Model: Model G-P2	Date: 18-May-06	No.: RG160001d
-------------------	-----------------	----------------

Subject: Firmware Release History (Printer)		Prepared by: S. Tomoe	
From: 1st Tech. Support Sec. Service Support Dept.			
Classification:	<input type="checkbox"/> Troubleshooting <input type="checkbox"/> Mechanical <input type="checkbox"/> Paper path <input checked="" type="checkbox"/> Other ()	<input type="checkbox"/> Part information <input type="checkbox"/> Electrical <input type="checkbox"/> Transmit/receive	<input type="checkbox"/> Action required <input type="checkbox"/> Service manual revision <input type="checkbox"/> Retrofit information

Model: G-P2	Date: 27-Jul-06	No.: RG160010a
-------------	-----------------	----------------

Subject: Uneven Image Density		Prepared by: S. Tomoe	
From: 1st Tech. Support Sec. Service Support Dept.			
Classification:	<input checked="" type="checkbox"/> Troubleshooting	<input type="checkbox"/> Part information	<input checked="" type="checkbox"/> Action required
	<input type="checkbox"/> Mechanical	<input type="checkbox"/> Electrical	<input type="checkbox"/> Service manual revision
	<input type="checkbox"/> Paper path	<input type="checkbo

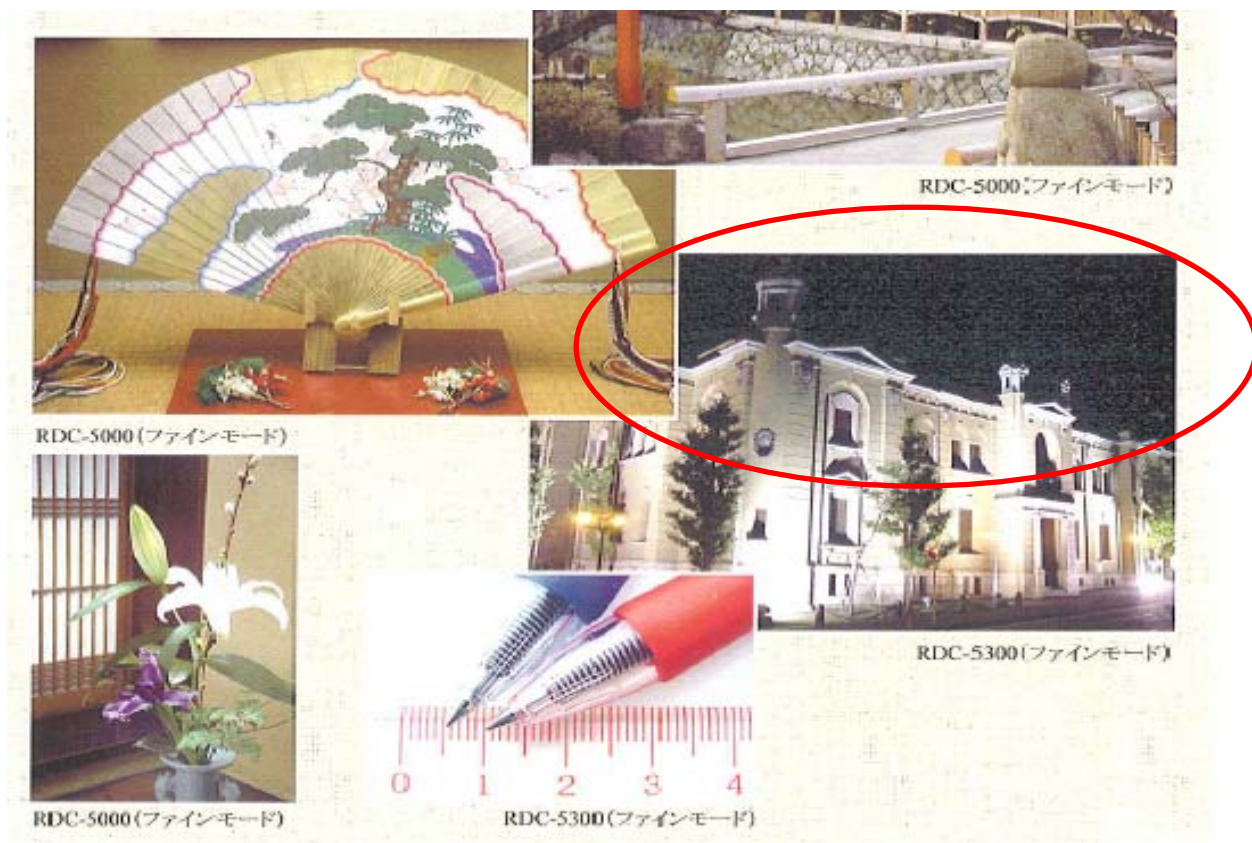
SYMPTOM

The image density of black solid image areas is uneven when printing in full-color mode.

Note: This occurs more often when printing at 1200x1200dpi with an RPCS driver, and at 600x600dpi with a PS3 driver.

CAUSE

The precision tool used at the factory to adjust the laser power of the laser diode was not calibrated correctly. As a result, the laser power was slightly weak (10% weaker than the specification) on machines produced from April 6th to the cut-in S/Ns listed below.

The laser power was changed to the optimum value from July 14, 2006 production.

- Change the following SP modes to the values shown below **in bold**.

Model	SP Mode	Change to this value:
G-P2a (G160 models) G-P2b (G161 models)	9-913-003	63
	9-913-004	139
	9-913-005	38
	9-913-006	252
G-P2b (G161 models) G-P2a (G160 models)	9-913-003	63
	9-913-004	63
	9-913-005	38
	9-913-006	176

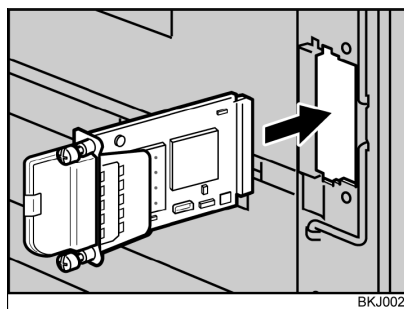
Previous types:
PCB, LAN card, and cover are
separate

New Type (IEEE802.11b
Interface Unit Type N):
Pre-assembled
